# 87C196JT 20 MHz Specification Update

Automotive

*December 1998*

Order Number: **272859-006**

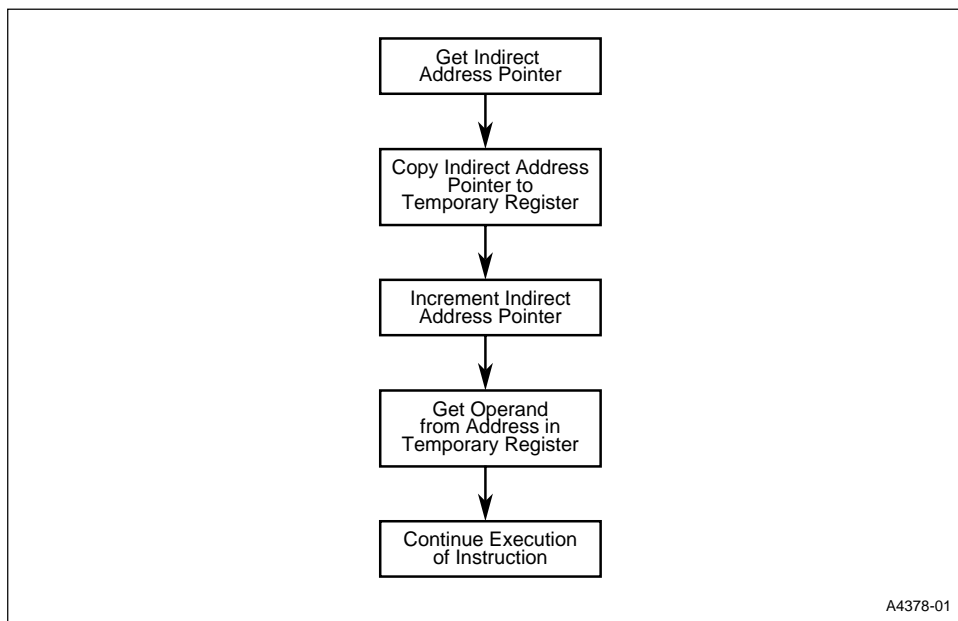
**Problem:** The EPA can lock up if overruns are handled incorrectly. Overruns occur when an EPA input transitions at a rate that cannot be handled by the EPA interrupt service routine. If no overrun handling strategy is in place, and if the following three conditions exist, a situation may occur where both the capture buffer and the EPA<sub>x</sub>\_TIME register contain data, and no EPA interrupt pending bit is set:

**Workaround:** Any one of the following methods can be used to prevent or recover from an EPA overrun situation.

- Clear EPAX\_CON.0  
When the overwrite bit (EPAX\_CON.0) is zero and both the EPAX\_TIME register than the buffer are full, the EPA does not consider a captured edge until the EPAX\_TIME register is read and the data in the capture buffer is transferred to EPAX\_TIME. This prevents overruns by ignoring new input capture events when both the capture buffer and EPAX\_TIME contain valid capture times. The OVRx pending bit in EPA\_PEND is set to indicate that an overrun occurred.

- Enable the OVRx interrupt and read the EPAX\_TIME register within the ISR  
If an overrun occurs, the overrun (OVRx) interrupt will be generated. The OVRx interrupt will then be acknowledged and its interrupt service routine will read the EPAX\_TIME register. After the CPU reads the EPAX\_TIME register, the buffered data moves from the buffer to the EPAX\_TIME register. This sets the EPA interrupt pending bit.

- Check for pending EPAX interrupts before exiting an EPAX ISR  
Another method for avoiding this situation is to check for pending EPA interrupts before exiting the EPA interrupt service routine. This is an easy way to detect overruns and additional interrupts. It can also save loop time by eliminating the latency necessary to service the pending interrupt. However, this method cannot be used with the peripheral transaction server (PTS).

**Figure 1. 16-bit System with EPROM**

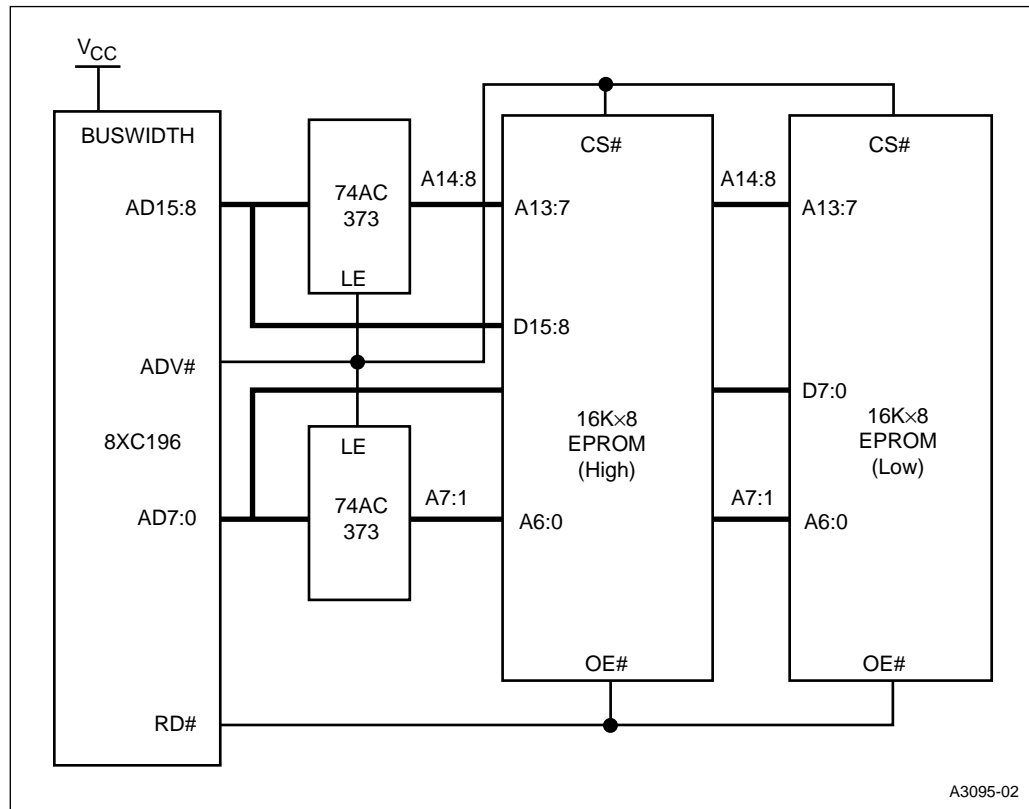
**1. High address inputs to the low EPROM should be A14:8 in Figure 15-18**

**Issue:** The next revision of the user’s manual will include the following corrected graphic.
